# SERVICE BULLETIN

Subject: New Decals Location in Engine Room      Bulletin Type:      Field Fix Conditional

Bulletin No: TS35-FC-2401

Vehicle Model: TS 35

**Figure-1**

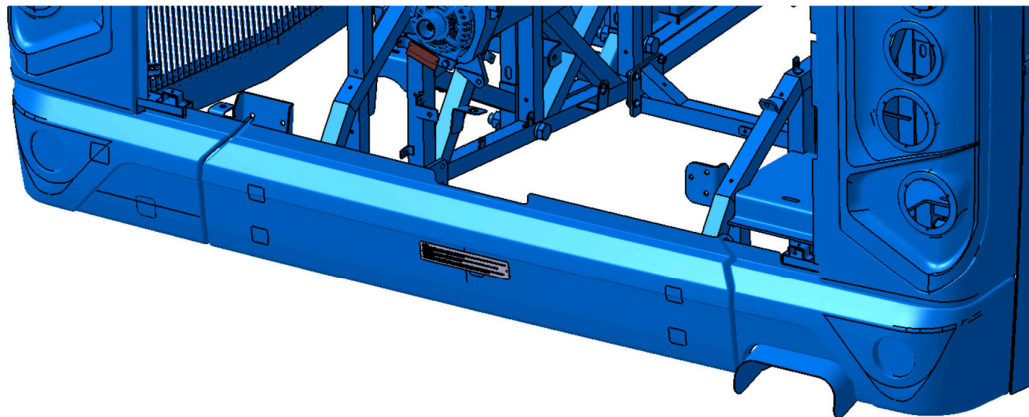
1- Open the engine cover. (See Figure-1).

Figure-3

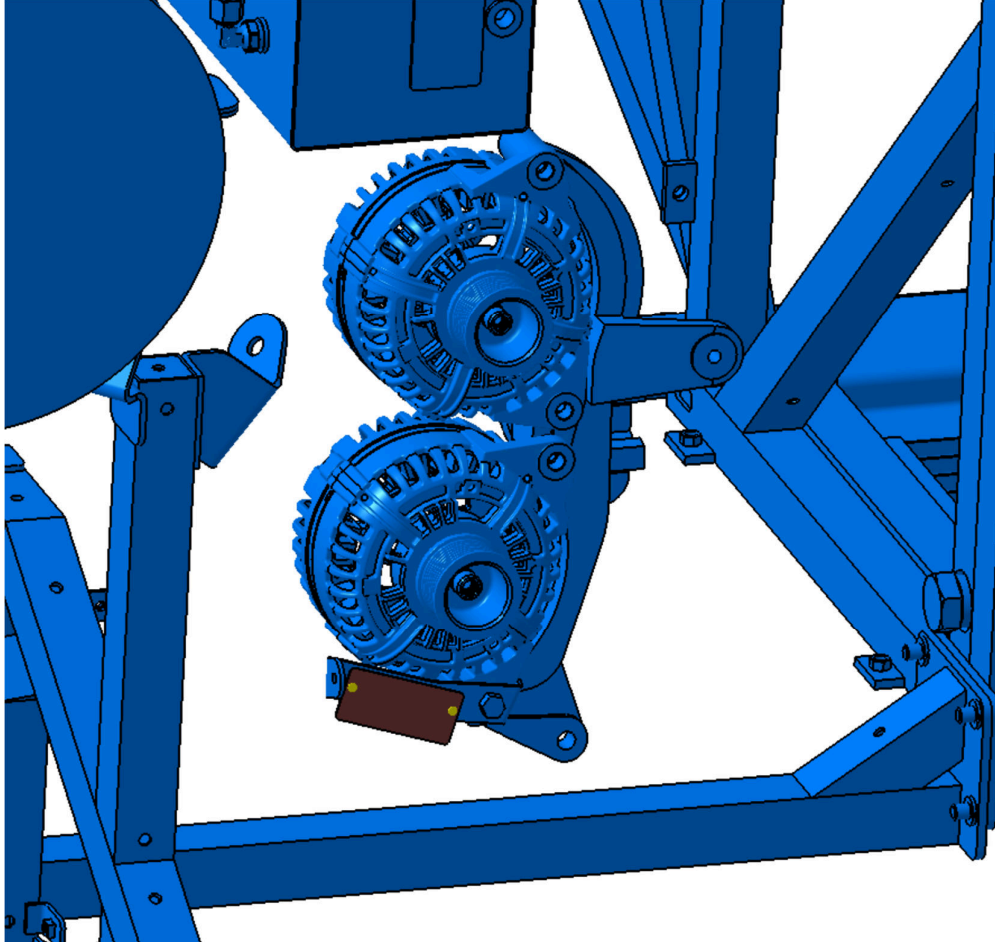
3- Mount the label numbered 9050-1044Y on the oil filling bracket with TC395107Y  
(See Figure-3).

Figure-4

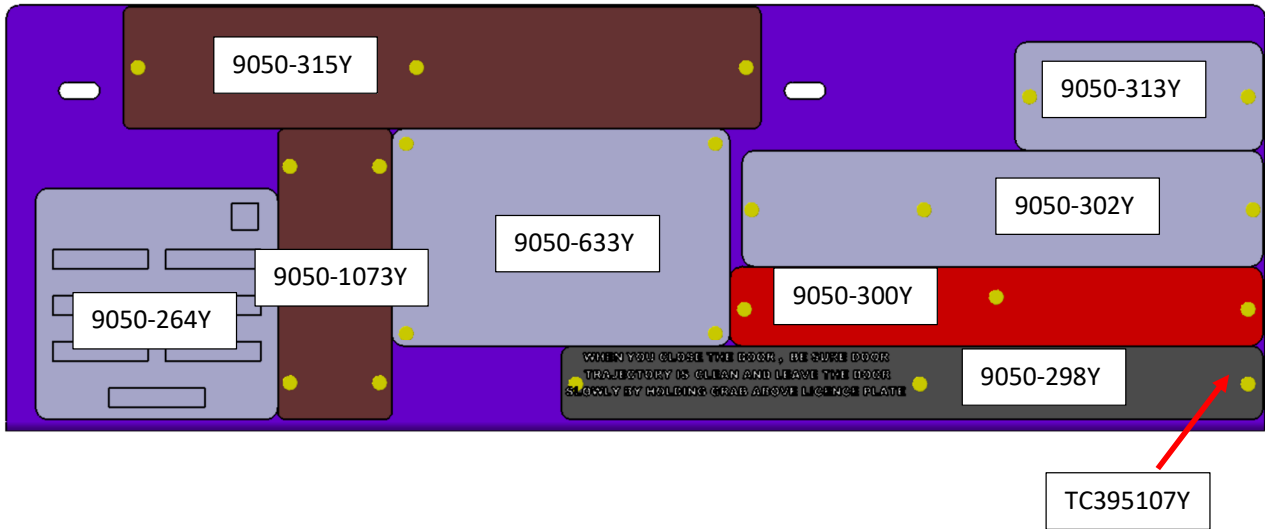
4- Mount labels shown in the picture below on the panel numbered 9325-7425Y with TC395107Y. (See Figure-4).

Figure-5

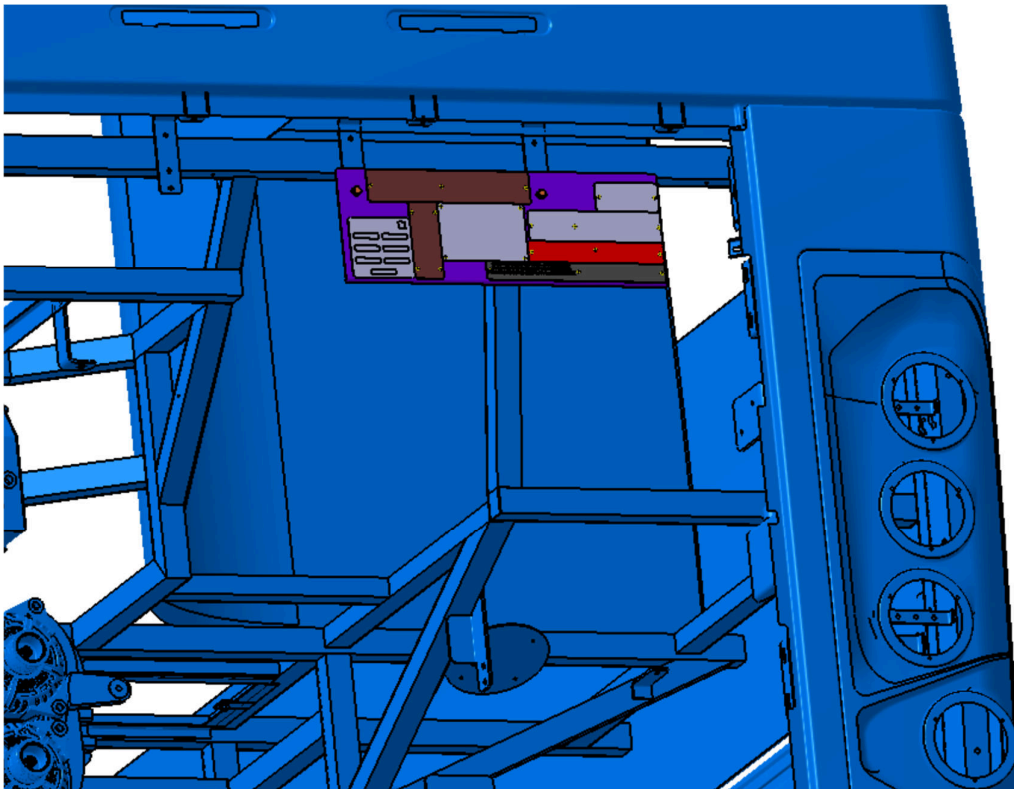
5- Mount the label panel numbered 9325-7301Y on the vehicle. (MF140005Y 2pc) (See Figure-5).
